City of Austin

Austin Transportation Department

RE: Austin Transportation Department's Comments on the Capital Express Central Build Alternative Layouts

ATD Design Concepts

Unutilized lanes

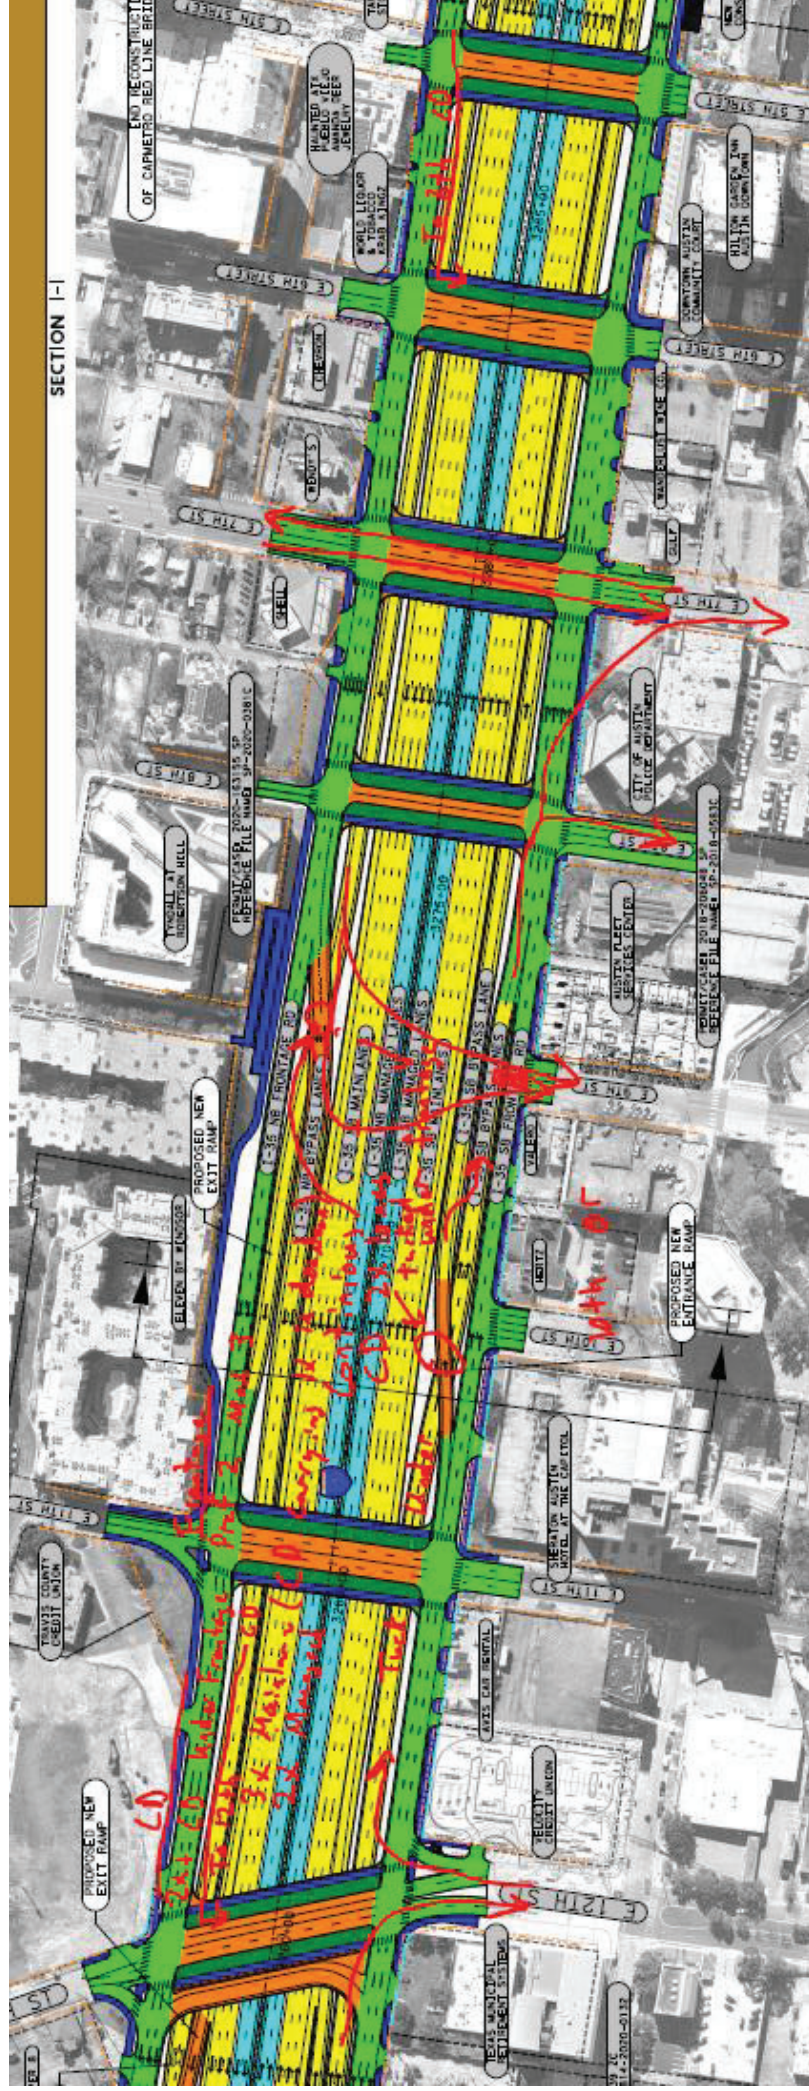
- ATD has identified segments with unutilized lanes in the analysis based on PM peak hour constrained volumes, indicating where forecasted vehicles cannot reach provided lanes due to upstream bottlenecks.

Ramping and portal options

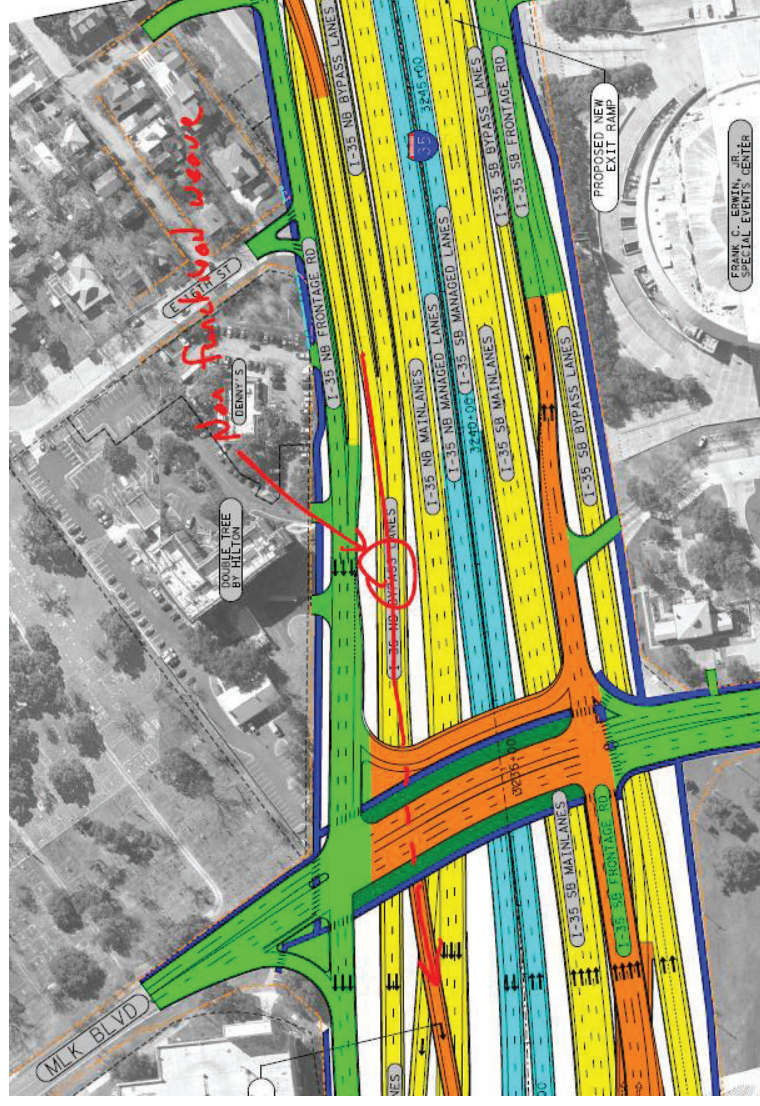
Weaving concern

E 38th 1/2 St

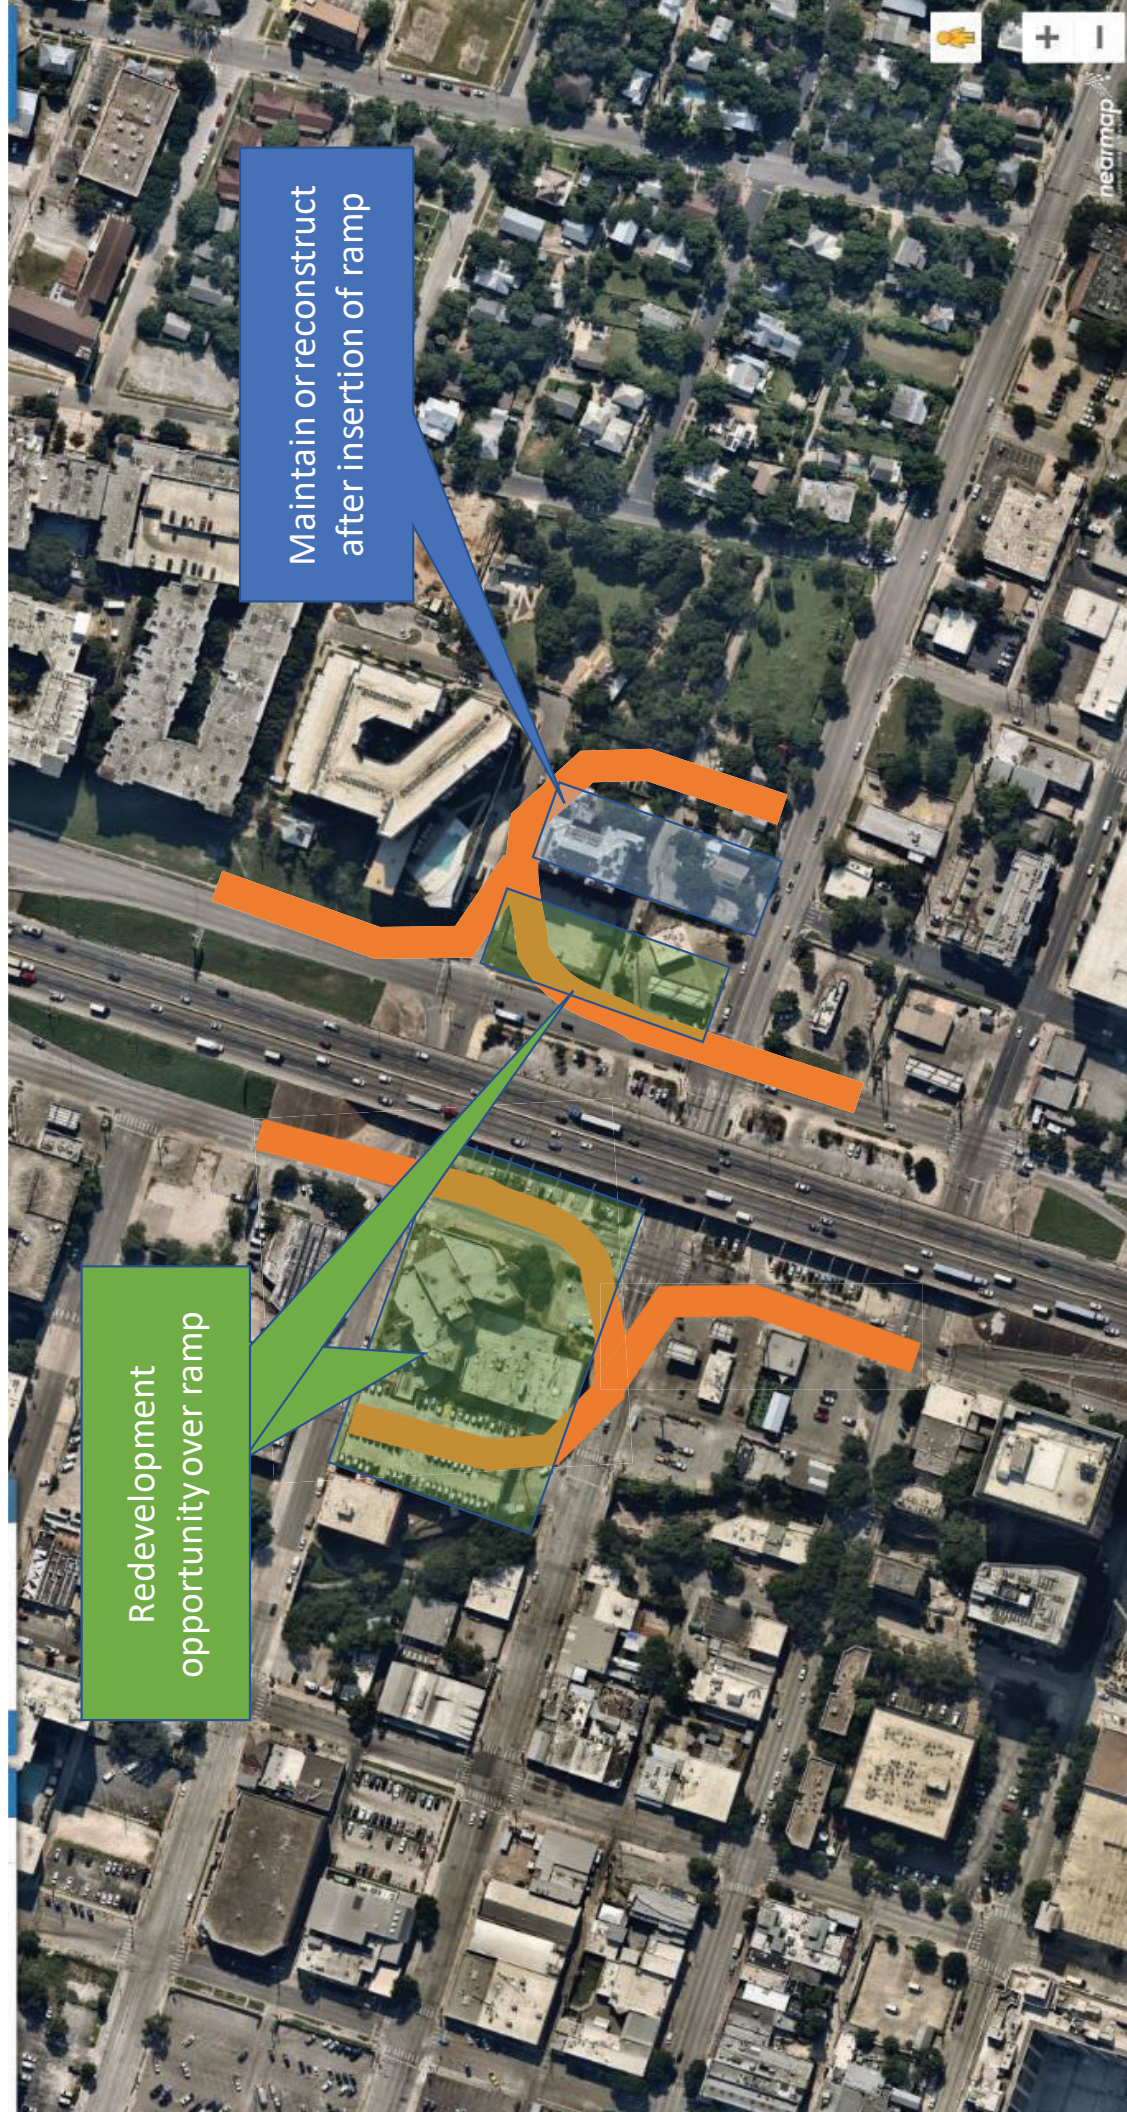
The northbound exit ramps for E 38th ½ Street and Airport Boulevard should be modified.

- Combine the exit ramps for both streets into a single ramp that continues through to access Airport Boulevard.
- Access to E 38th ½ Street would be provided through a portal exit under the frontage road and the existing Fiesta Mart parking lot.
- Potential for a similar southbound ramp removal needs review.

Maintain or reconstruct
after insertion of ramp

Redevelopment
opportunity over ramp

Cantilever design: extended to other segments?

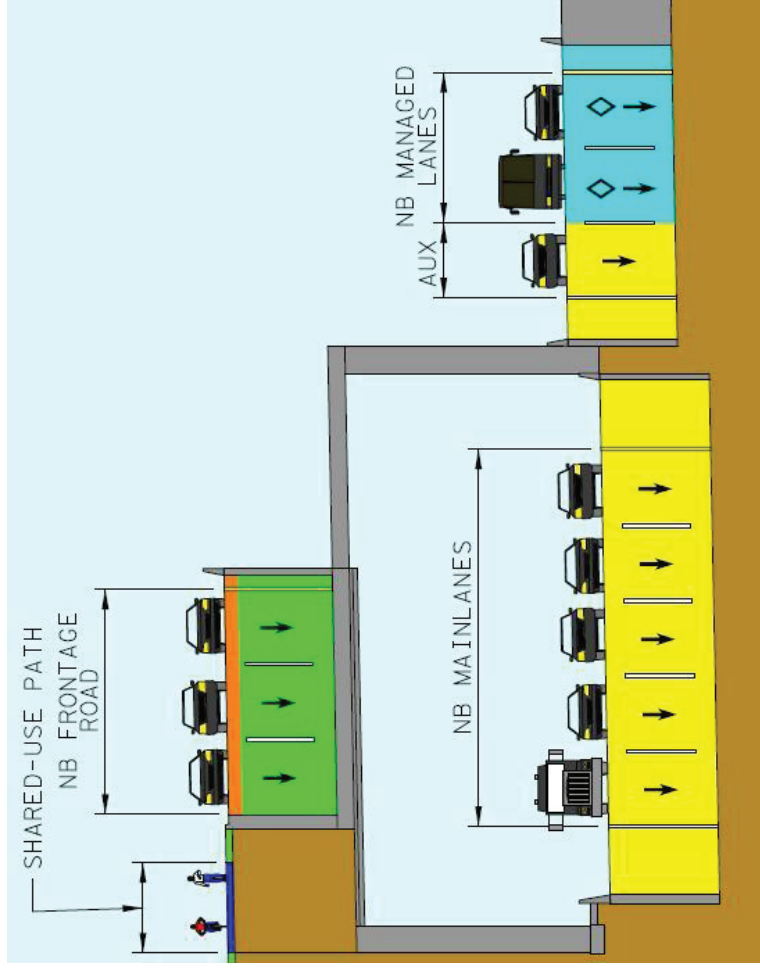
Cantilevered frontage roads provide an opportunity to reduce the overall footprint of the project where ramping can be maintained.

- Cantilevered frontage roads were designed through the most constrained segment near UT. Can this concept be replicated along most of the remaining segments where additional right-of-row is being proposed, particularly where portals or other innovative ramping can be designed in conjunction with cantilevers?
- What is the value engineering (cost/benefit analysis) of constructing cantilevers rather than displacing properties?
- Realignment of six frontage road lanes has a potential width reduction of 72 feet.
- ATD would like to learn more about TxDOT’s concept of bringing the frontage roads closer together through downtown in an urban boulevard couplet configuration; however, ATD has concerns about intersection operations, ramp access, and pedestrian/bicycle crossings that need extensive evaluation.
